Product Change Notification - GBNG-05INPY729

Notification subject:
CCB 3820 Final Notice: Implement Microchip Label changes for selected Microsemi (DCS and POE) board products.

Label Change for DCS and POE Board Product

Outer Carton Label – DCS (Mainboard / CAP Card)

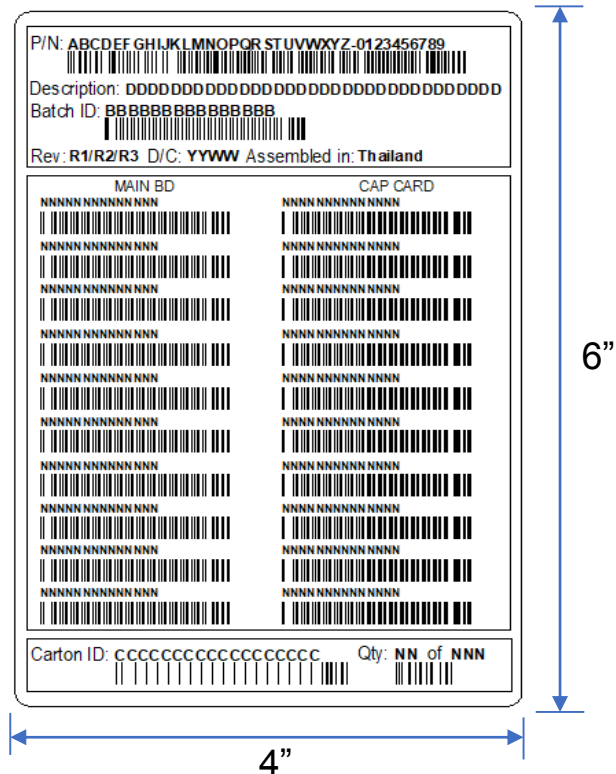
Pre Change

PRODUCT P/N: 2281600-R QTY: 1 Revs: A7/K/A	
 PRODUCT TYPE: ASR-81605ZQ SINGLE	
 RoHS PRINTED CIRCUIT BOARD ASSEMBLY MADE IN SINGAPORE OTHER ARTICLES OF FOREIGN ORIGIN AS MARKED THEREON	
ATT:	D/C: 1610
BD	CAP CARD
 S6A0963486FF	 S6C07EE0024C
CARTON ID: S106Y001332

Post Change

P/N: ABCDEF GHIJK LMNOPQR STUVWXYZ-0123456789	
 Description: DDDDDDDDDDDDDDDDDDDDDDDDDDDDDDDDDDD	
Batch ID: BBBB BBBB BBBB BBBB	
 Rev: R1/R2/R3 D/C: YYWW Assembled in: Thailand	
MAIN BD NNNNN NNNNN NNN  NNNNN NNNNN NNN  NNNNN NNNNN NNN  NNNNN NNNNN NNN  NNNNN NNNNN NNN  NNNNN NNNNN NNN  NNNNN NNNNN NNN  NNNNN NNNNN NNN  NNNNN NNNNN NNN  NNNNN NNNNN NNN  NNNNN NNNNN NNN  NNNNN NNNNN NNN 	CAP CARD NNNN NNNNN NNNN  NNNN NNNNN NNNN  NNNN NNNNN NNNN  NNNN NNNNN NNNN  NNNN NNNNN NNNN  NNNN NNNNN NNNN  NNNN NNNNN NNNN  NNNN NNNNN NNNN  NNNN NNNNN NNNN  NNNN NNNNN NNNN  NNNN NNNNN NNNN  NNNN NNNNN NNNN 
Carton ID: ccccccccccccccccccc Qty: NN of NNN

Remark:
 - Qty : NN of NNN → No. of board in each label of No. of total board in the carton
